ADDENDUM #4
June 23, 2010

For the project Titled:
FAIRMOUNT AVE. TOWNHOUSES
CFRC # TN00400001209G
CHA SOLICITATION # D-306-12

PROJECT: Fairmount Avenue Townhouses	PROJECT NO. 09478
NARRATIVE FOR ADDENDUM NO: 4	PREPARED BY: TLM
	DATE: 06/23/10

DETAIL: TREE PROTECTION DETAIL

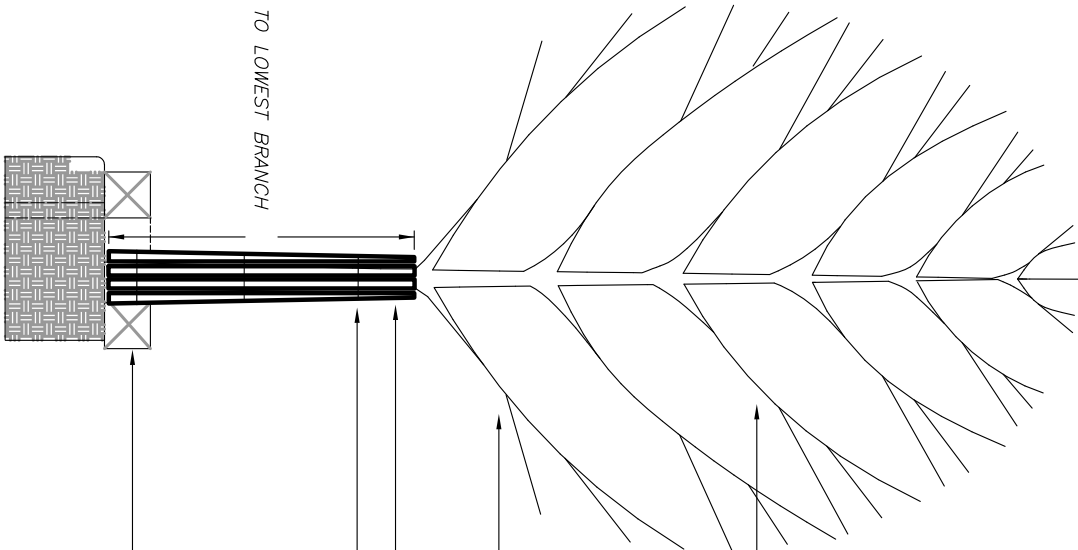
ITEM 1 Add attached detail 18/C9.0 – City of Chattanooga Tree Protection

trees will be demolished. Replace demolished trees with 2” caliper trees – species of tree to be determined by City of Chattanooga Urban Forester. Provide City of Chattanooga tree protection (per detail 18/C9.0) for all other trees within 10 feet of western Right of Way line. Survey indicates eight (8) trees to require tree protection.”

TREE PROTECTION: INSTALL A SHIELD OF 1" X 4" WOODEN PLANKS COMPLETELY AROUND EACH TREE TRUNK FROM GROUND LEVEL TO WHERE THE TRUNK BEGINS TO "BRANCH OUT". ATTACH SUCH PROTECTION WITH 12 GAUGE GALVANIZED WIRE AROUND TREE TRUNK AT THE TOP, BOTTOM, AND MIDDLE OF THE PLANKING.

TREE PIT PROTECTION: PROTECT TREE PITS AND PIT VEGETATION FROM FALLING, SLIDING, OR WASHING BUILDING MATERIALS BY PLACING BALES OF STRAW AROUND THE PERIMETER OF EACH PIT OR OVER THE TOP OF THE PIT AS DIRECTED BY THE URBAN FORESTER. STRAW BALES SHALL REMAIN WHOLE AND UNBROKEN AND HAVE NO LOOSE STRAW THAT MAY BECOME SCATTERED AROUND THE AREA.
